Access Compliance Report Public Rights-of-Way (Curb Ramps)

Main Street: GATEWAY_DR Cross Street: ORANGE_KNOLL_DR Location: SW

ADA ID: RPRK211013171631 Ramp Type: Type 4 - Parallel Initial Pass/Fail: Fail Overall Compliance: No Severity Score: 2

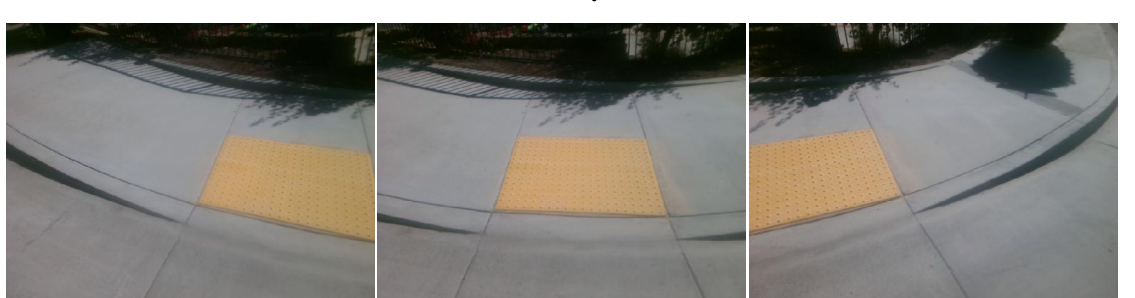
Compliance	Description	Data	Compliance	Description	Data
N/A	Ramp Length LT (in)	116	N/A	Ramp Length RT (in)	81
Yes	Ramp Width LT (in)	83	Yes	Ramp Width RT (in)	82
Yes	Ramp Run Slope LT (%)	5.9	Yes	Ramp Run Slope RT (%)	3.1
No	Ramp Cross Slope LT (%)	4.3	Yes	Ramp Cross Slope RT (%)	0.7
N/A	Landing Present	N/A	N/A	DWS Provided	N/A
N/A	Landing Length (in)	N/A	N/A	DWS Contrast	N/A
N/A	Landing Width (in)	N/A	N/A	DWS Length (in)	N/A
N/A	Landing Run Slope (%)	N/A	N/A	DWS Full Width	N/A
N/A	Landing Cross Slope (%)	N/A		DWS Offset Type	N/A
N/A	Landing Movement Obstructed?	N/A	N/A	DWS Offset Left (in)	N/A
	Landing Movement Type	N/A	N/A	DWS Offset Right (in)	N/A
N/A	Landing Shared	N/A			
N/A	Clear Space	Yes			
N/A	Clear Space To Crosswalk (in)	N/A			
N/A	Marked Crosswalk 1	No	N/A	Marked Crosswalk 2	No
	Crossing 1 Direction	NE		Crossing 2 Direction	NW
N/A	Marked Crosswalk 1 Width (in)	N/A		Marked Crosswalk 2 Width (in)	N/A

Possible Solutions:
Remove & Replace Curb Ramp With Two New Directional Ramps or Equivalent.
